Subject: RE: Tract C-1 Drainage Exhibit

Tract C-1 Manzano Mesa

LE: SOUTHERN BLVD. DRAINAGE STUDY

DRAINAGE REPORT FOR SOUTHERN BLVD. 90% SUBMITTAI

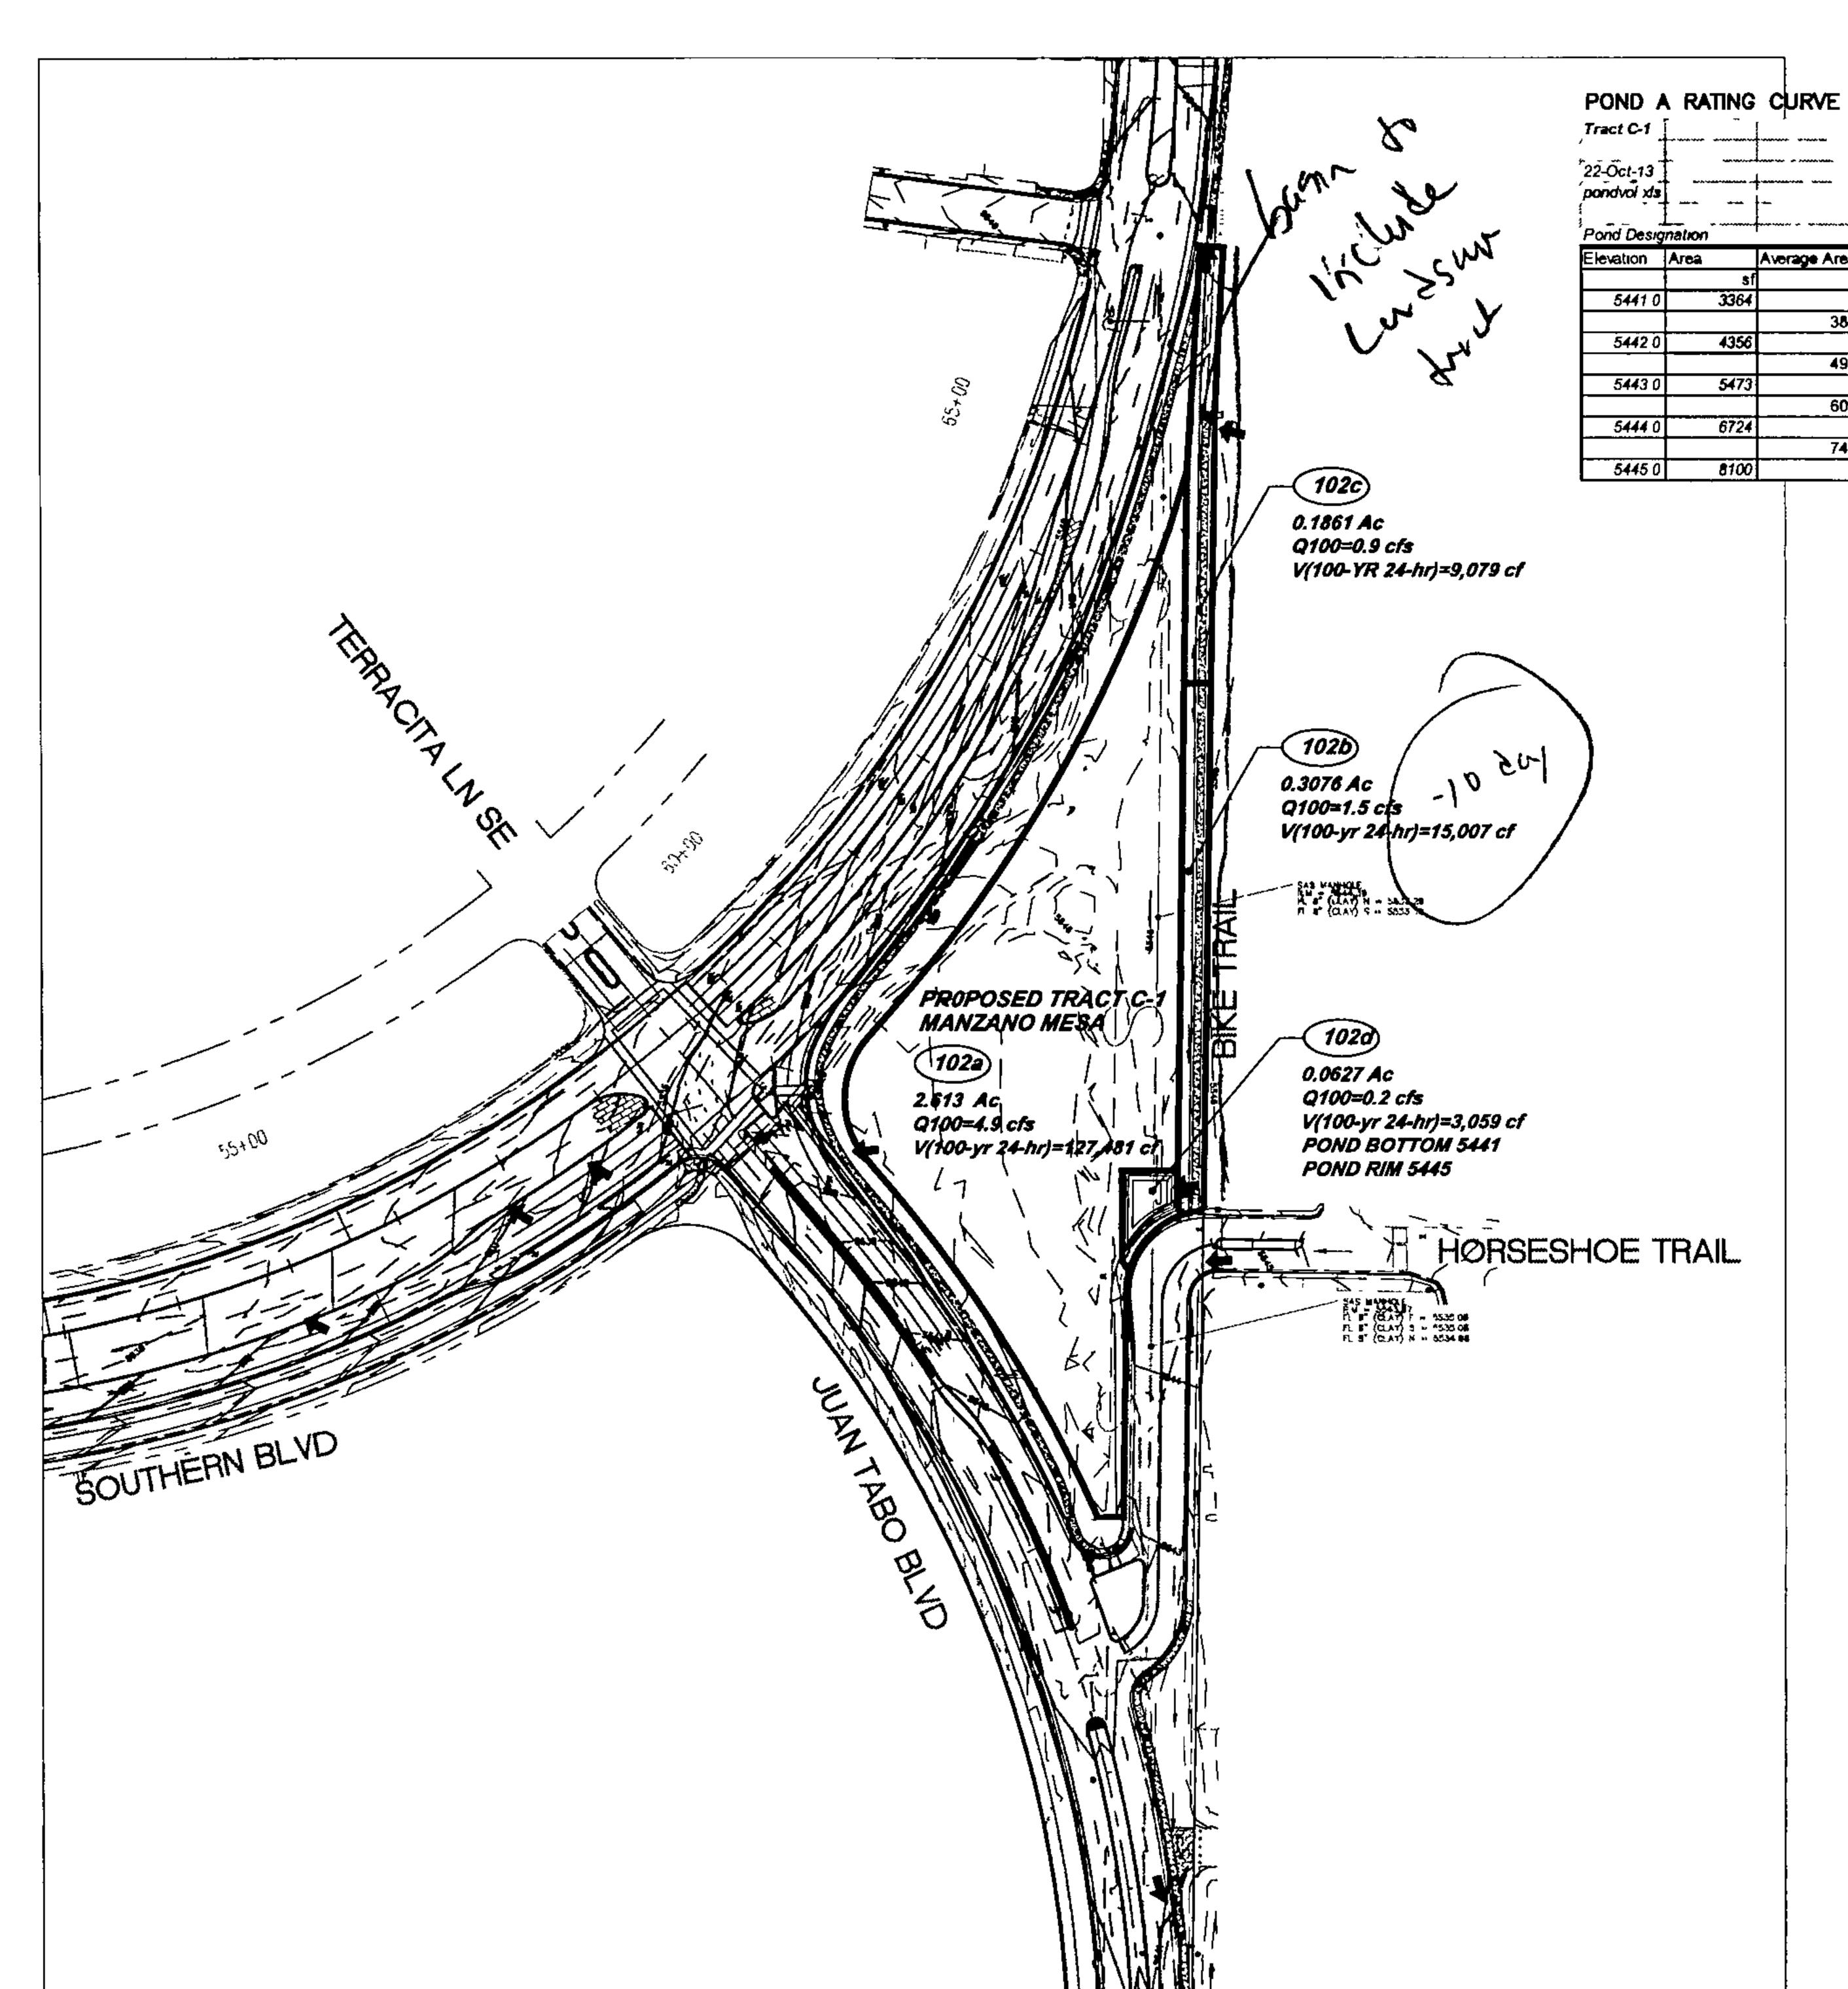
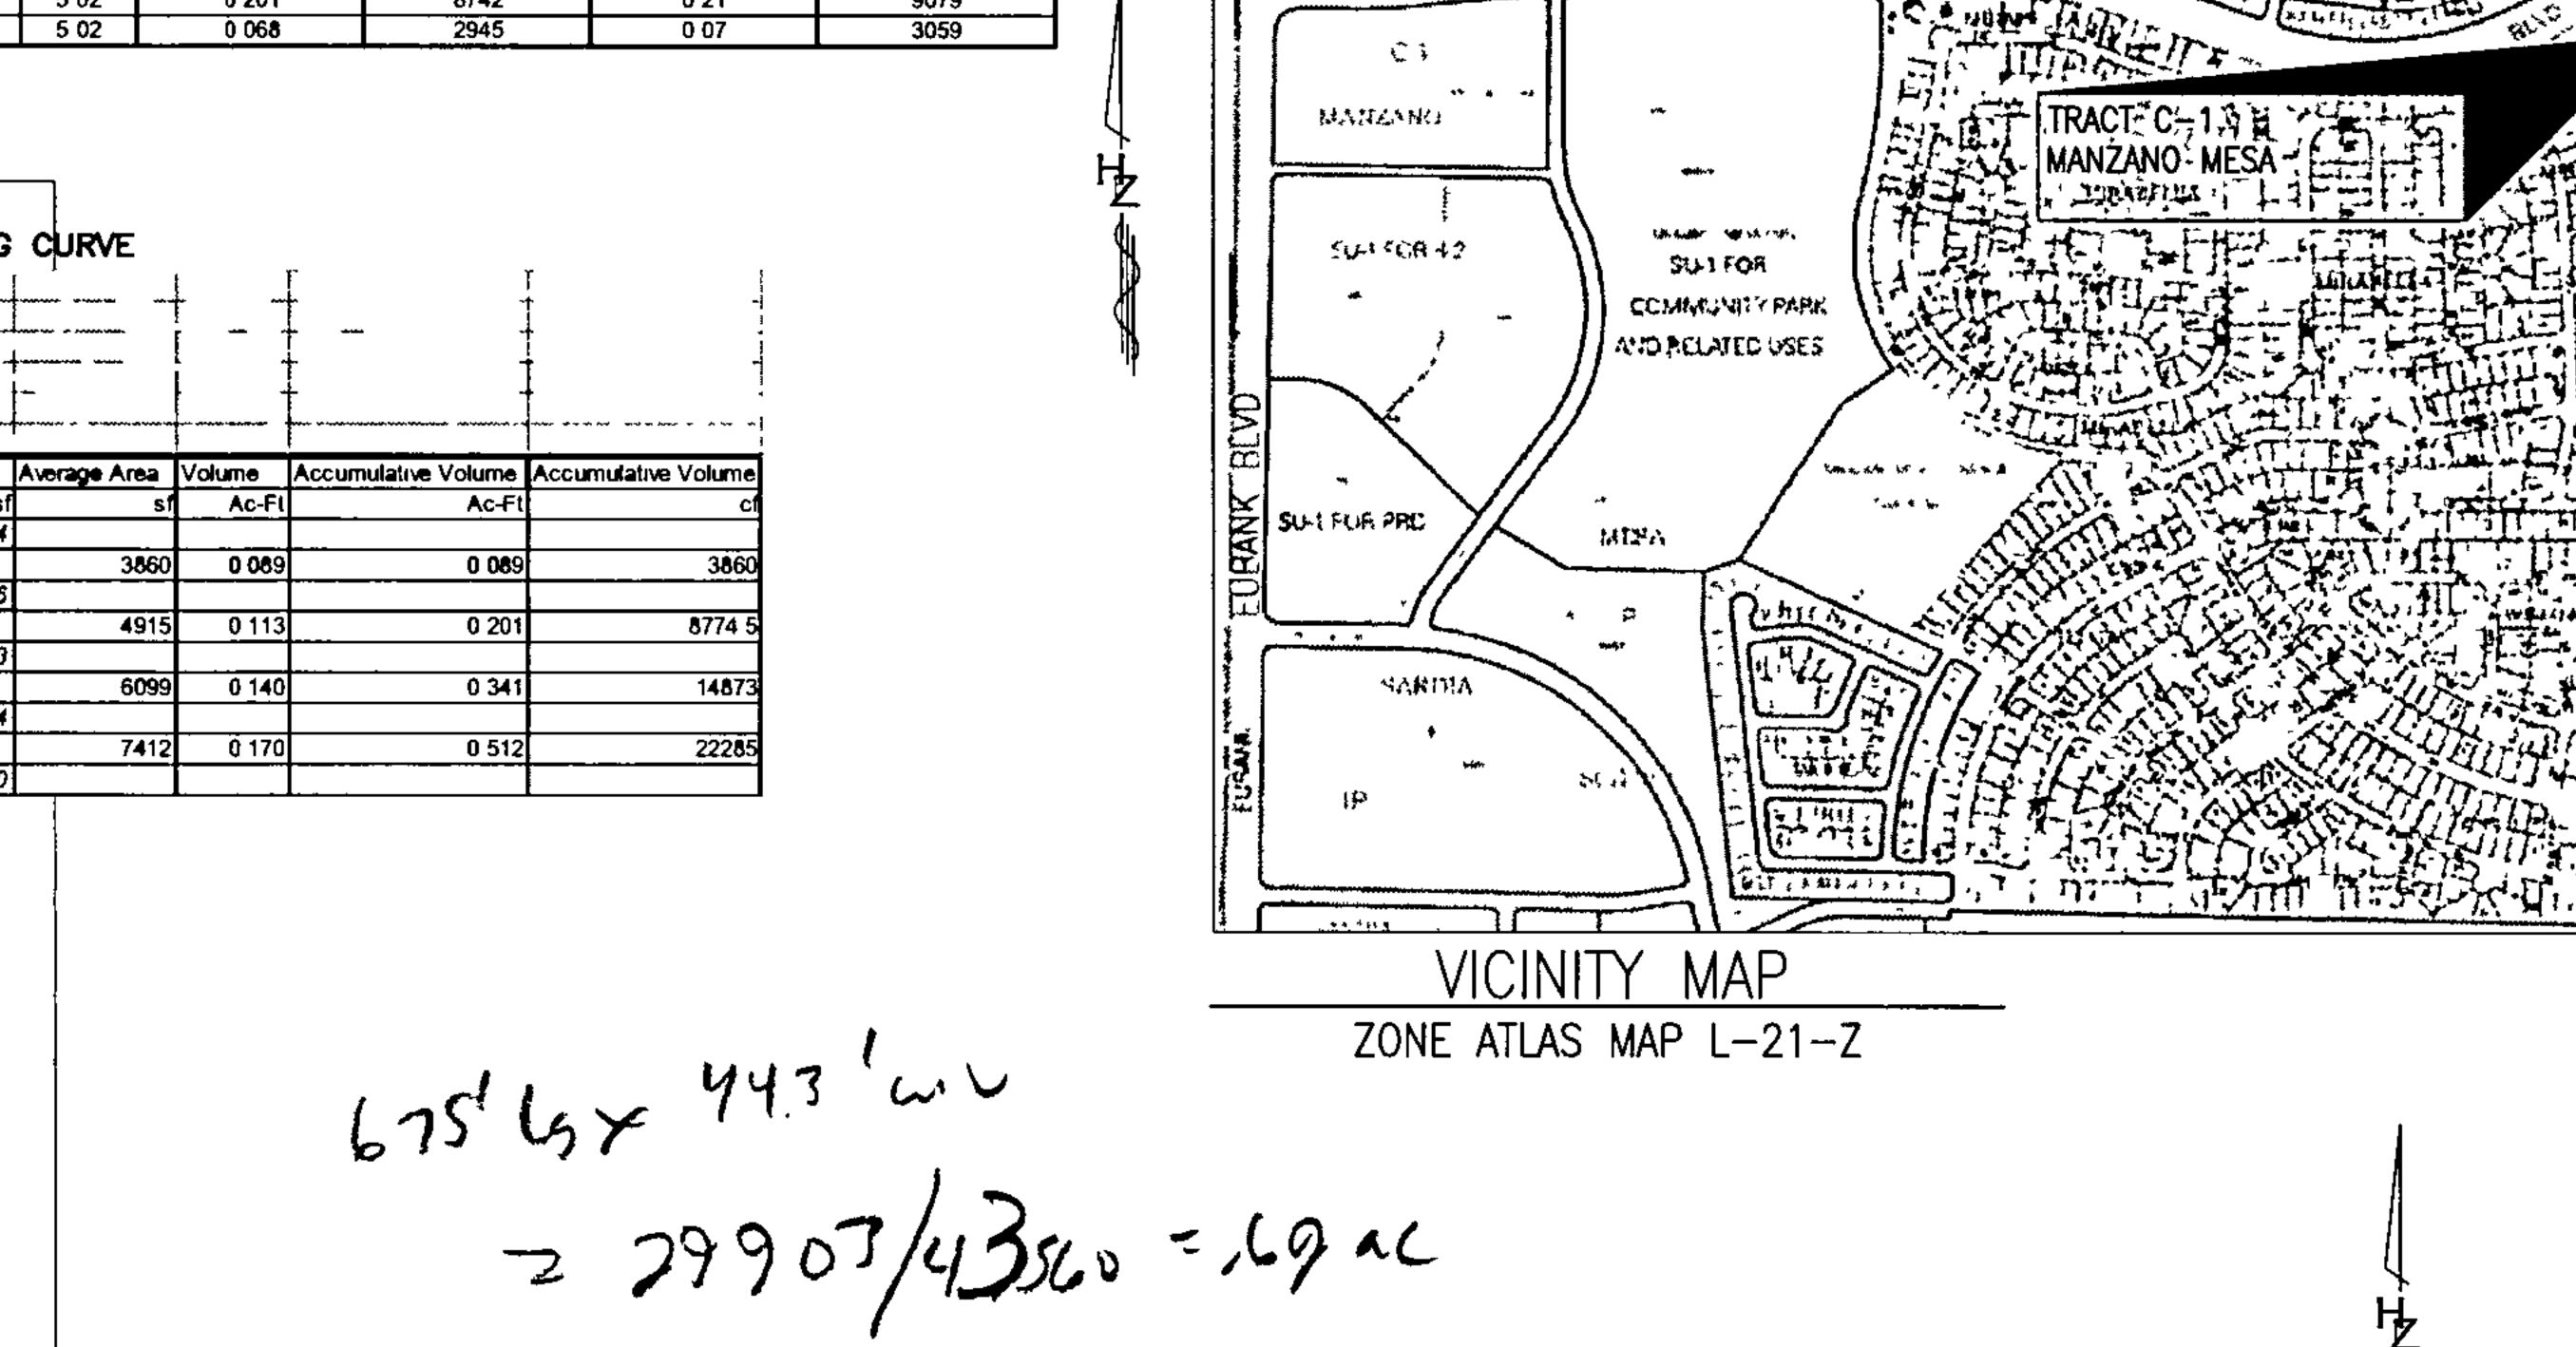
I have reviewed the exhibit and provide the following comments:

- 1. It appears your drainage basins do not account for the landscape area between the wall and the path. Once the water leaves the private landscape area and hits the public area, the water becomes public.
- 2. Since this is a retention pond, you should use the 100 yr -10 day storm not the 100 yr -24 hour storm to size the pond.

1. Why does the public drainage easement encompass an area outside the pond?

We will update the exhibit and make a formal submittal. The public drainage easement outside the pond exists to allow at some future time a swale to be installed to allow the water to directly discharge onto Horseshoe trail.
